Subject: NRC Staff Detailed Comments on Industry-Developed Draft Technology Inclusive
Content of Application Project Guidance Document
Sent Date: 6/10/2021 9:18:52 AM
Received Date: 6/10/2021 9:18:00 AM
From: Sebrosky, Joseph

**Technology Inclusive Content of Application Project
For Non-Light Water Reactors**

**Technology Inclusive Guidance for Non-Light Water Reactor
Safety Analysis Report:
Content for a Licensing Modernization Project-Based Affirmative Safety Case**

**Document Number
SC-16166-104 Rev A**

Figure 1. Relationship of TICAP to an Advanced Reactor License Application

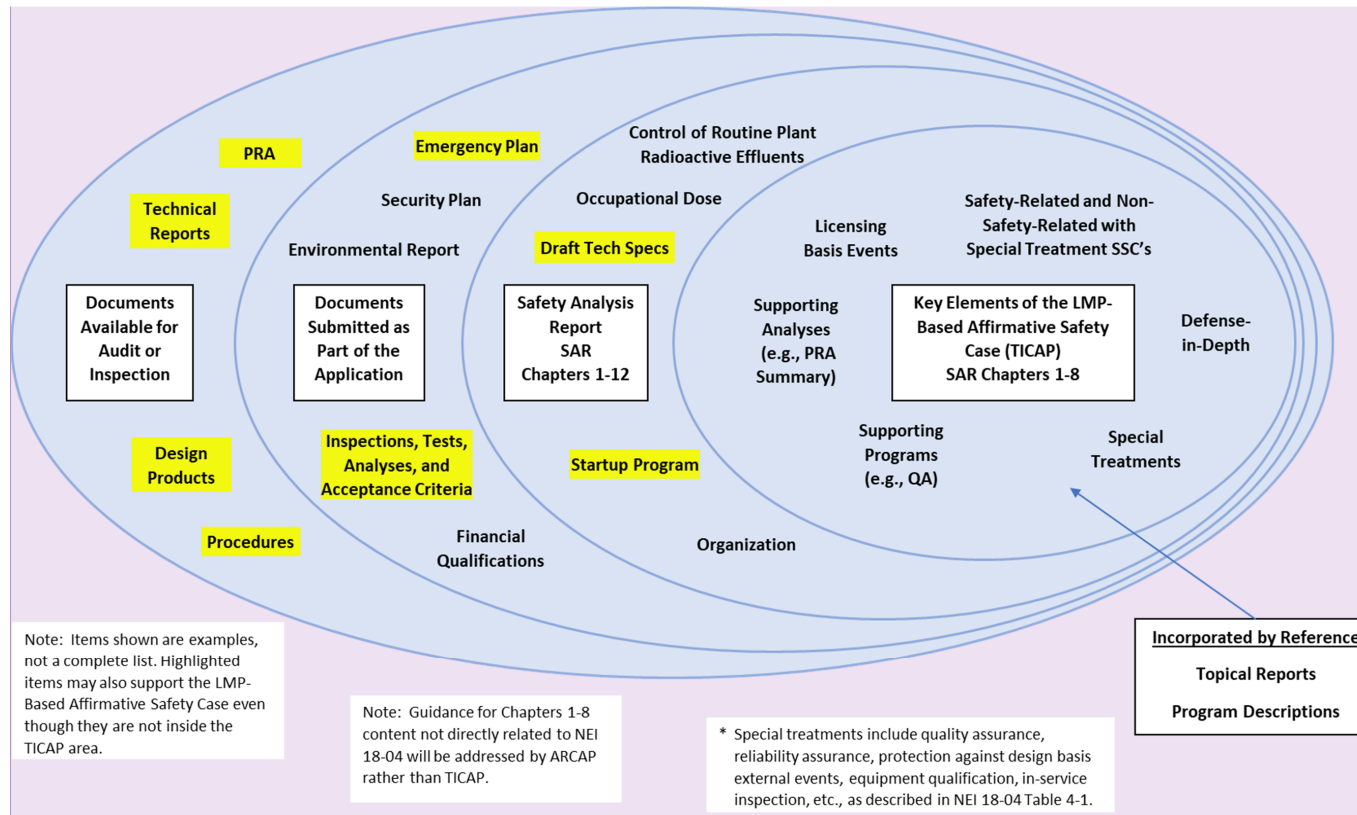
Commented [A14]: I thought TS were supposed to be final at the COL stage... correct or not?

Commented [A15R14]: Delete 'Draft'?

Commented [A17R14]: We can clarify with Southern. There might not be an issue with the term "draft" since the applicant provides the tech specs and it is up to the NRC to review them and attach them to the license. That is, tech specs are attached to the license and the "draft" tech specs provided in the application cease to have a regulatory footprint when the license is issued
